**Robatel Technologies Responses to the
NRC Second Round of Request for Additional Information
for the
Model N° RT-100 Package
Docket N° 71-9365**

The NRC Request for Additional Information (RAI) identifies information needed by the staff with regard to its review of the Robatel Technologies Safety Analysis Report, Revision N°2, dated September 18, 2013. The RAI questions are grouped by chapter number and title from the Safety Analysis Report, along with the Robatel Technologies Response. The response addresses the question where applicable, references the locations in the SAR and/or supporting documents where revised information can be located.

Figure 1- Upper Impact Limiter Dose Rate Response for Co-60

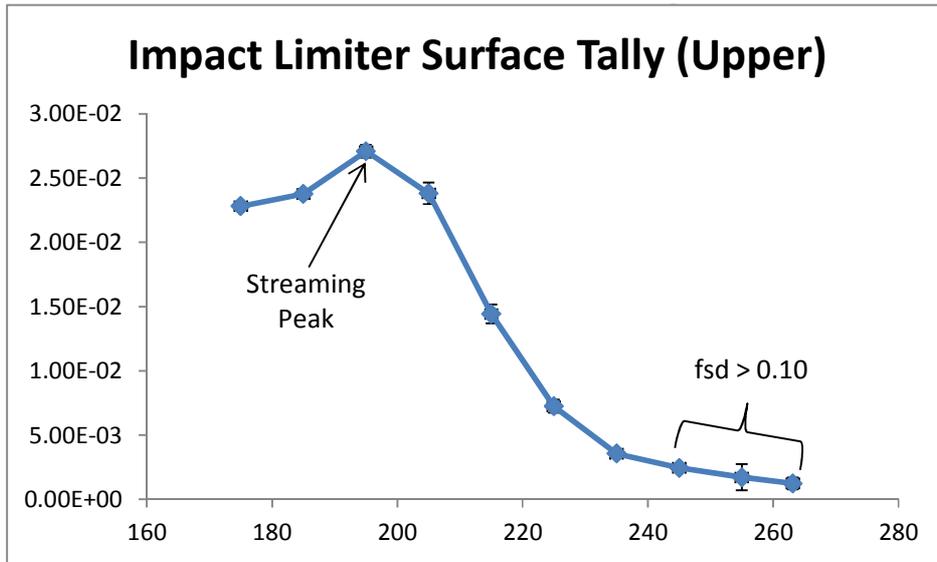
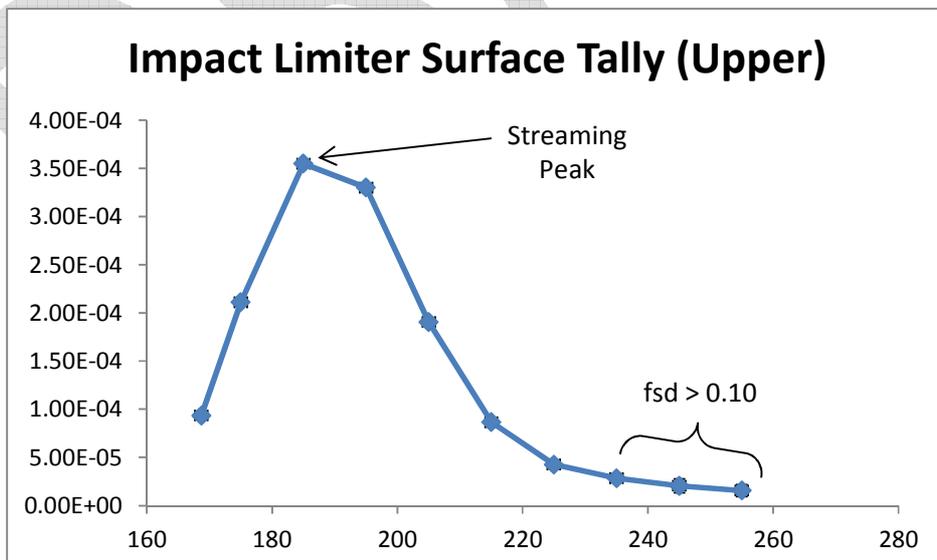
Demonstrate that the response method used is accurate and reliable with focus on mid- and low-energy particles and prove that all MCNP shielding calculations have converged properly.

In addition, the staff's confirmatory calculations using the applicant's models indicated that most of the low mid-to-low energy particle MCNP calculations do not converge with the time specified in the models and the applicant confirmed this during a meeting. Hence, the results presented to the NRC in the application might have been erroneous and misleading. The applicant needs to provide results that are accurate and reliable.

The dose rate response for the upper impact limiter for Co-60 is plotted in Figure 1. From Figure 1 it is clear that the peak dose rate locations are captured by the tally, and the upper end of the upper impact limiter does not contain a peak location. This same figure is presented for Cs-137 in Figure 2. The same conclusions can be drawn.

Figure 8.1.4-5. Test Apparatus for Measuring the Helium Leak Rate through the Quick Disconnect Valve Cover Plate

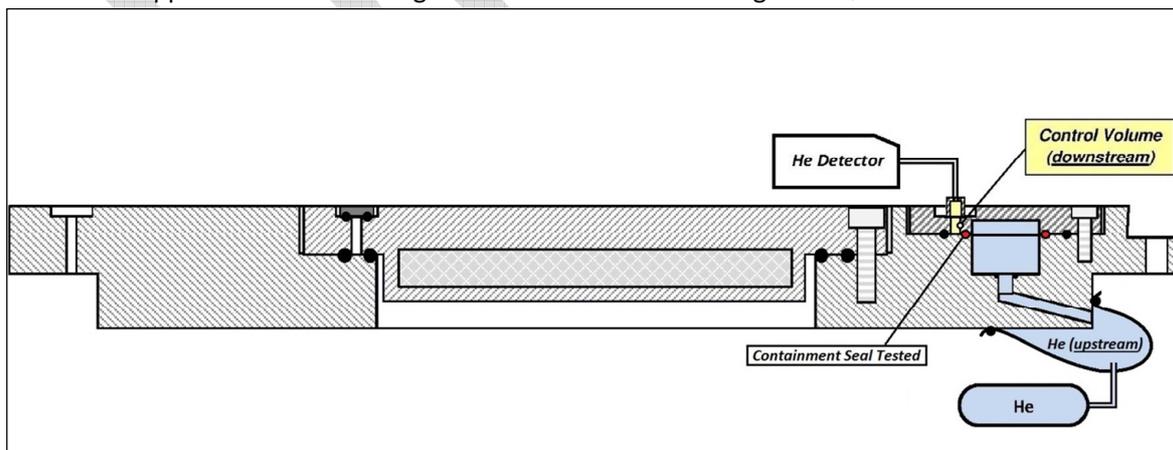
Clarify the quick disconnect valve and quick disconnect valve cover plate leakage test procedures.

The quick-disconnect valve and its cover plate can be tested either with the primary lid off or on the cask body. In the first configuration with the primary lid off, a bag containing helium is attached to the lower portion of the primary lid. In the alternate configuration with the primary lid on, the secondary lid is removed, covered with plastic sheet and taped, and the opening is used to inject helium into the cask cavity. The only difference in the configurations is how the helium is injected. The containment boundary and the test method are identical. Sections 8.1.4.3 and 8.1.4.4 have been updated to include figures to show the test configurations. Figures 8.1.4-5 and 8.1.4-6 from the SAR have been provided below for reference.
